**OBSERVATION IN RELATION TO
LANDS AT KNOCKMAREE, ST. LAURENCE'S ROAD,
CHAPELIZOD, DUBLIN 20**

**LUCAN TO CITY CENTRE CORE BUS CORRIDOR SCHEME
COMPULSORY PURCHASE ORDER 2022**

PLOT REFERENCE NO. : 1023(1).1f & 1023(2).2f

An Bord Pleanála Case number: HA29N.314942

Excerpt from Lands to be Compulsory Acquired Deposit Map (Sheet 10 of 13) (Drawing no. DR-GG-010)

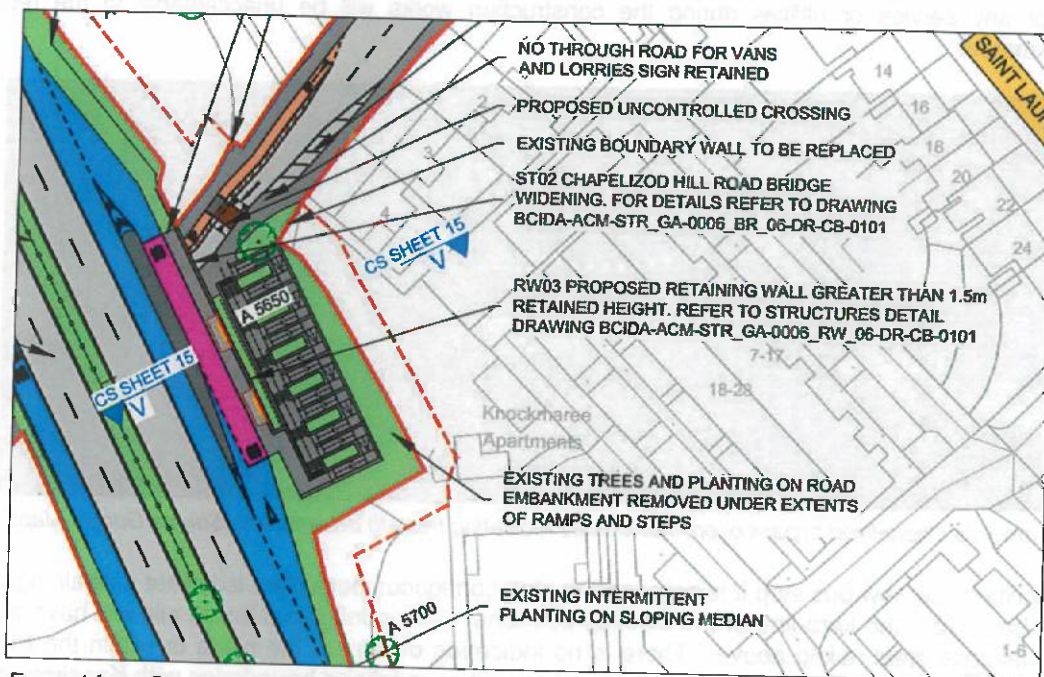
- 2.7 The lands that are the subject of this Compulsory Purchase Order (CPO) on a permanent and temporary basis are indicated on the Lands to be Compulsory Acquired Deposit Map (Sheet 10 of 13) (Drawing no. DR-GG-010), an excerpt of which is indicated below.

Excerpt from General Arrangement Drawing (Sheet 20 of 31) (Drawing no. DR-CR-020)

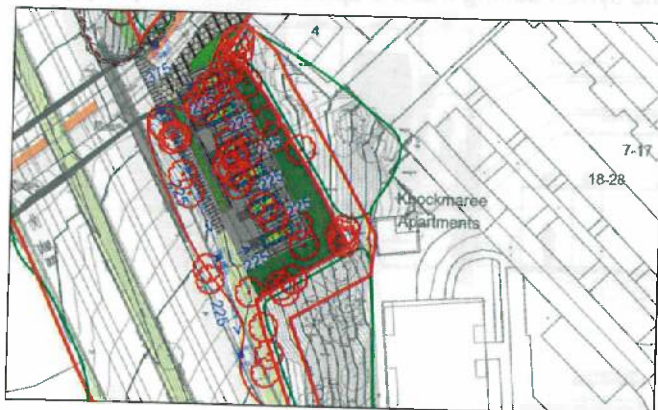
- 3.3 The nature of the works at and adjacent to the Knockmaree apartments are shown on Drawing no. DR-CR-0020 (Sheet 20 of 31), an excerpt of which is provided on the following page. All works are proposed in this location to the immediate north-west of the Knockmaree development to facilitate east bound traffic. These works are described within section 4.5.2.1 of Chapter 4 of the Environmental Impact Assessment Report (EIAR) as being:

- 3.4 The scale, form as well as the nature and extent of the steps and ramp is notable in seeking to facilitate the c. 10m height differential. This creates a heavily engineered solution that includes 18 ramps to provide wheelchair / pushchair access to the proposed new bus stop that is located on the proposed widened bridge and to the immediate west of Knockmaree. The geographical position and location of the ramps must also be considered in that in order to access them a person would need to push up the 110m steep slope from St. Laurence's Road. Irrespective of the benefits in terms of access for all, it is highly questionable of how often the ramps would be used in this instance given that a high frequency bus service exists through Chapelizod Village (Bus route no. 26) and the relatively short distance to the city centre; and the lack of residential development to the west side of the bypass.

View towards Chapelizod bypass over Knockmaree indicating trees to be removed (Source Google Maps and CPO)

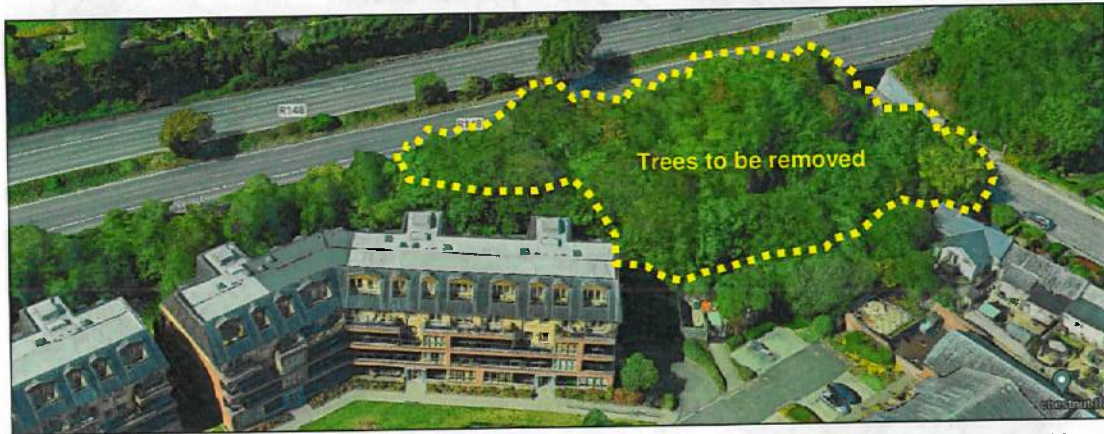
- 3.5 The proposed works is indicated as resulting in the loss of c. 40 mature trees. These are indicated within the Arboricultural Impact Assessment as being 'Unsurveyed existing tree features to be removed'. Their proposed removal and impact has therefore not been accurately assessed within the accompanying EIAR that forms part of the CPO. The trees indicated for removal are shown at the top of the next page in red.

3.6 The drawing (Drawing no. DR-LL-0020 (Sheet 20 of 31) does not adequately indicate the tree cover on the steeply sloping lands, and the extent of the tree cover that will be lost. Assuming that all trees will also be removed within Temporary CPO lands, to facilitate the heavy engineered ground works and supporting structure proposed, we have estimated that all bar the lowest trees will be lost. This is based on a retaining structure being required within a few metres of the substation, and the Temporary CPO extending a corridor around these works to facilitate them. This will have a profound negative impact on the visual amenity and feeling of privacy within Knockmaree.

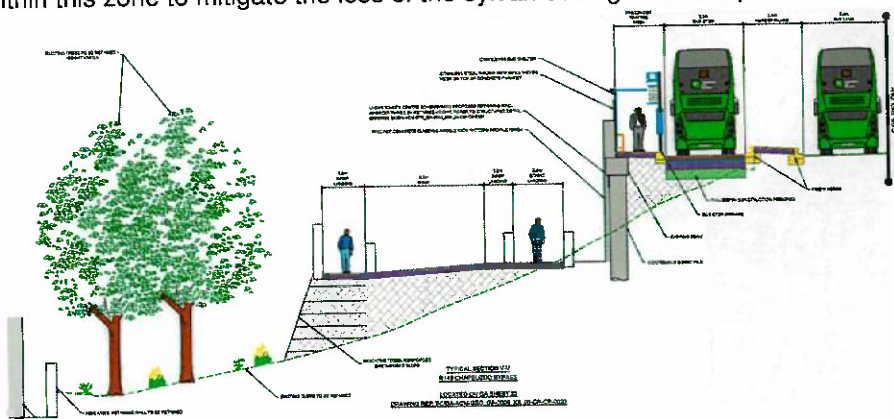
3.8 To facilitate the new bus stop it is proposed to sink contiguous bore piles to create a retaining wall some 7.7m back from the kerb-line of the existing bus lane. This contiguous bored pile will have a solid wall and stainless steel railing above. There is no indication on any of the plans or within the EIAR of any proposed acoustic barriers along this or any of the other redefined boundaries with Knockmaree. This is a significant failing of the scheme. In addition we note that the ramp and steps to provide a link from Chapelizod Hill Road to the new proposed bus stop will be created by a significant cut and fill exercise (indicated by the green dashed line below) that will be reinforced on its eastern boundary with Knockmaree with a 70° reinforced earthworks slope that will extend a further c. 11m out from the proposed new contiguous bored pile wall. This section indicates the inability to provide any tree planting within this zone to mitigate the loss of the sylvan setting that the apartments currently enjoy.
